# BURRIS/WAGNON ARCHITECTS, P.A.

## ADDENDUM NO. 5

Re: **GS# 354-050**  
**Tenant Improvement - DMH (1<sup>st</sup>, 2<sup>nd</sup>, 10<sup>th</sup>, 11<sup>th</sup>, 12<sup>th</sup>)**  
**Robert E. Lee Building**  
**(Office of Capitol Facilities)**  
**(Department of Finance and Administration)**  
**Jackson, Mississippi**

Revised West Side Interior Elev. Front View of Dais Facade

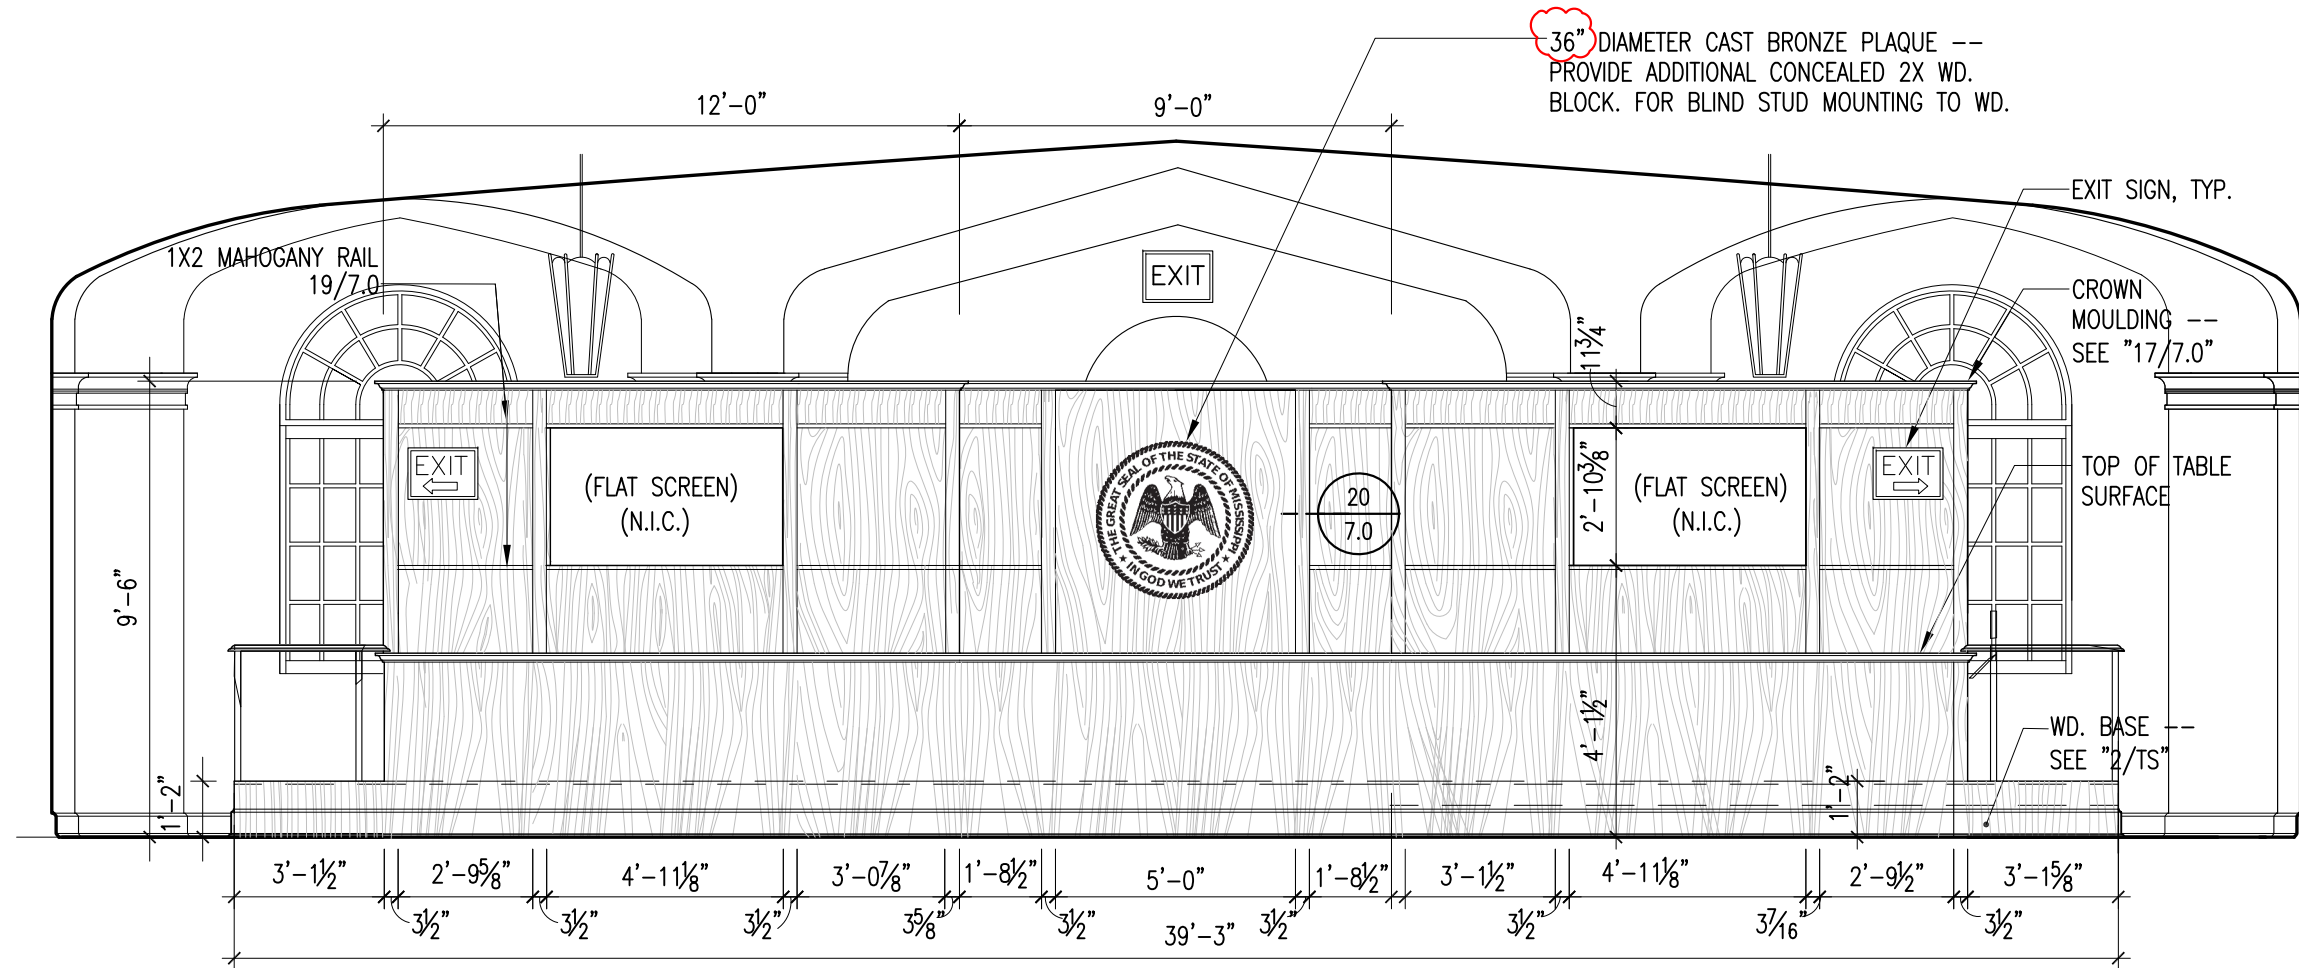
**Item No. 2:** Refer to **Sheet 7.0, Drawing 4, West Side Interior Elev. Front View of Dais Facade**, and modify based on the attached Exhibit "C".
